# A White Paper on Technical Plans for a Proposed Reuse-Water Reservoir in Dry Wash, Ivins, Utah

By Wayne Pennington, PhD  
14 January 2024

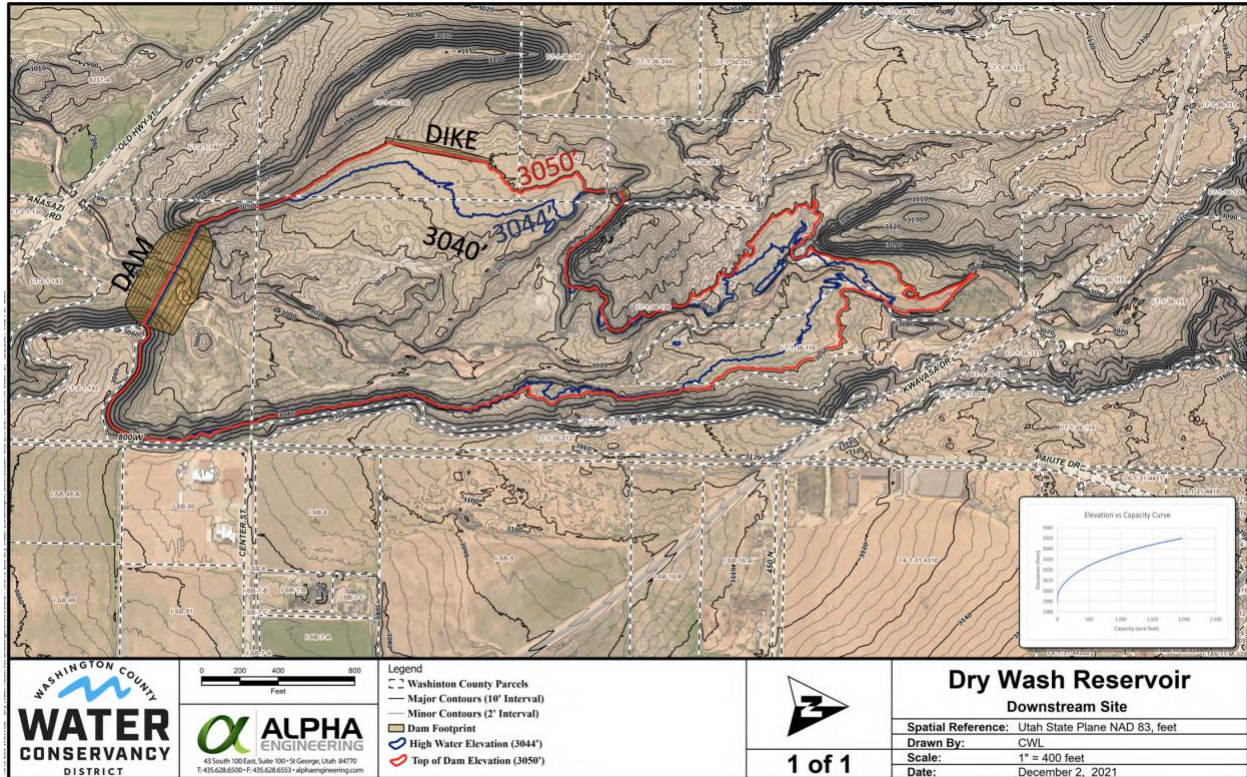
The 3044' reservoir design provides a capacity of 1500 acre-ft, and occupies an estimated 66 acres of surface area. The low-water level (common in all designs) occupies a surface area of 19 acres. The difference of 47 acres represents the area that is alternately submerged (when the reservoir is full) and subaerially exposed (when the reservoir has been drawn down to conservation level).

While not shown in these figures, it is worth noting that long-standing plans for development west of the reservoir includes nearby properties that are at an elevation lower than 3040'. At a high-water level of 3044', these properties could arguably be at risk for water incursion.

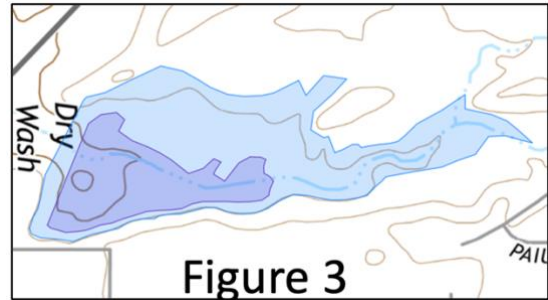
Figure 3 shows a sketch of the reservoir at 3044' (light blue) and at 3016' (dark blue). The difference, 47 acres, which will be muddy and harboring insect populations part of the time, or dry and enabling dust to be dispersed by winds, is an area of concern to all residents and a potential source of large expense to the City of Ivins, which will be responsible for mitigating these issues.

Figure 4. Top: Close-up map of broad flat area on west side of proposed reservoir. The contour interval (thin lines) is 2 ft. The black arrow shows the approximate location from which the picture at bottom was taken.

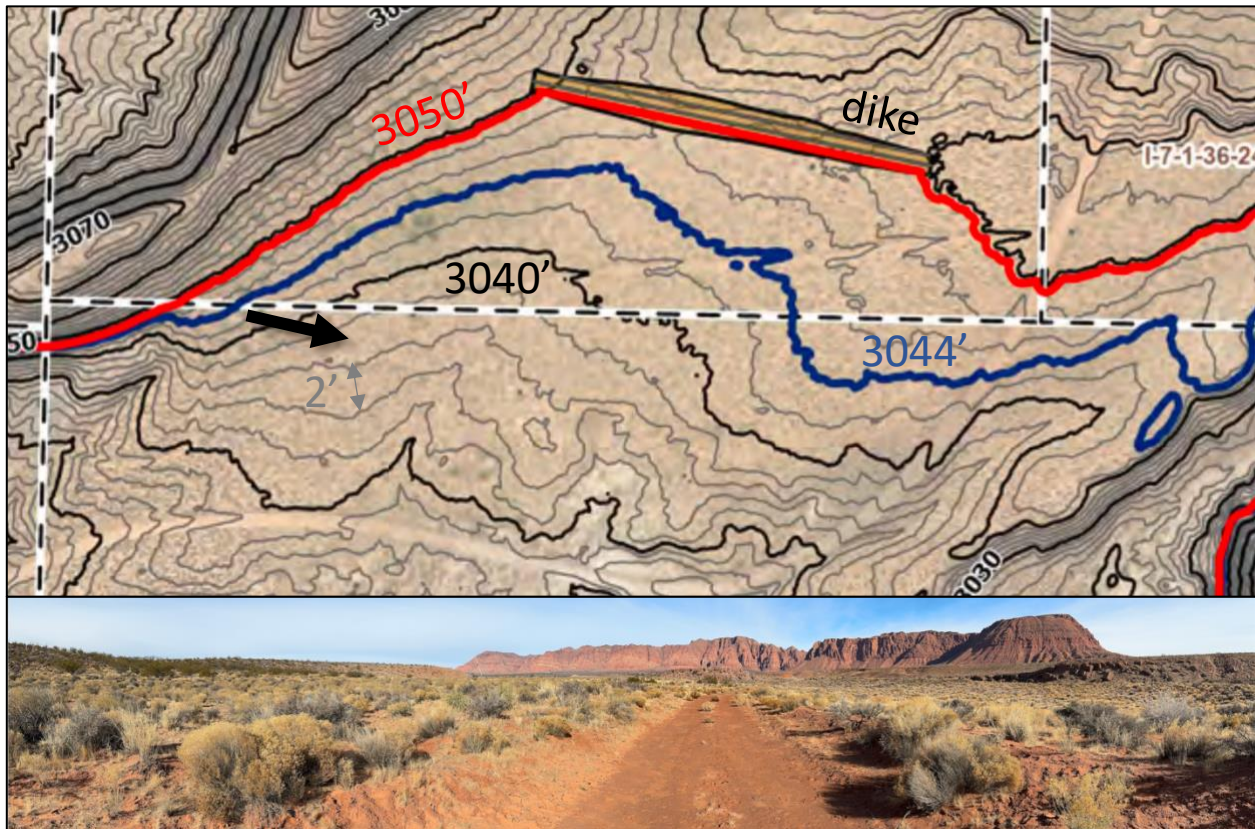
Bottom: This wide-angle photo shows part of the broad, nearly flat, area that would be alternately submerged and exposed in the current WCWCD design. Within a year of filling the reservoir, all the vegetation shown here will be gone, and, when dry, the soil and precipitate from the reservoir will be subject to dispersal by wind.

Notice on the map in Figure 4 that by increasing the maximum water elevation from 3040' to 3044' the broad shallow area (and other places) increases in the area exposed to alternate wetting and drying by 16 acres, from 31 acres to 47 acres (using simple maps). Notably, the 2004 EA did not evaluate the environmental effects of having the large area exposed to alternate submergence and exposure of the 3044' design.

It has been proposed that the broad shallow area may be reduced by excavation under parts of it, and depositing the excavated material on other parts of it. This may be feasible, but a huge volume of material required to be moved in order to resemble the 2004 EA design.

Figure 5. Reservoir design using 3038' high water elevation. The thick blue line in this map is the 3038' contour. A potential hiking trail is shown in green.

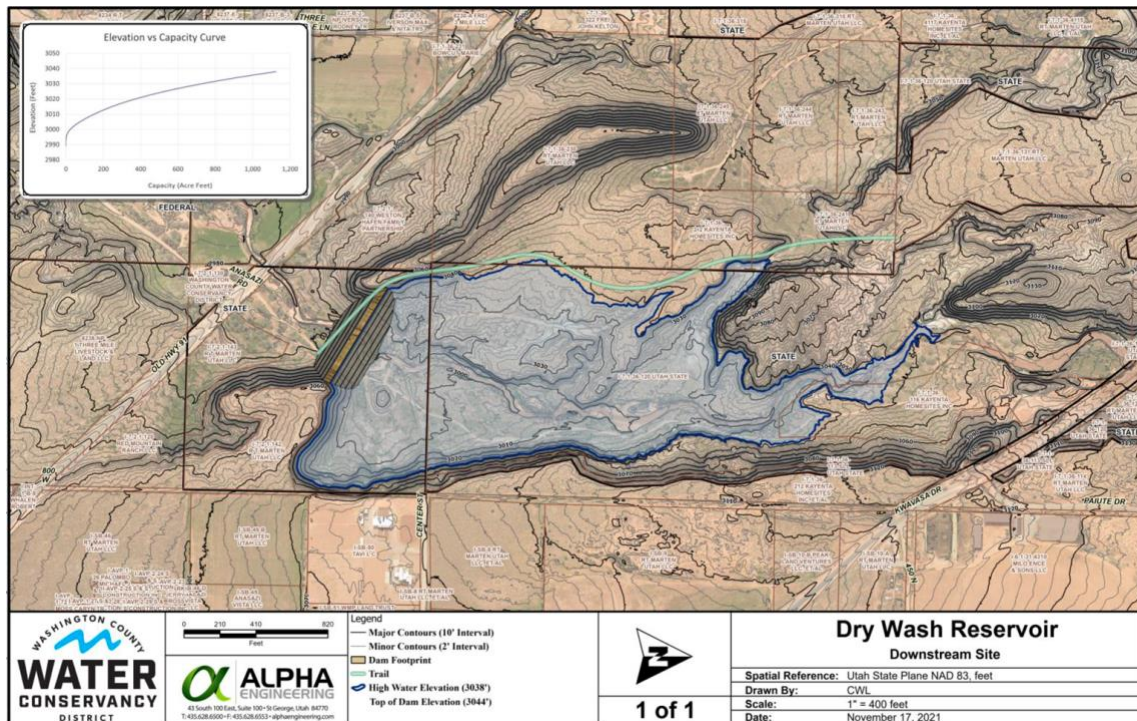
The 3038' reservoir design has a capacity of about 1150 acre-ft. This design removes the need for a large dike and greatly reduces the surface area that would be alternately submerged and subaerially exposed, to perhaps 25 acres, but it also reduces the storage capacity by 14% compared with the reservoir in the 2004 EA. Some manageable excavation of the smaller remaining shallow area could restore some of this capacity. The reservoir would also be further removed from the development planned to the west, reducing concern for water incursion there.

I recommend consideration of this design, with a high-water level of 3038', if a reservoir is to be constructed at this site.
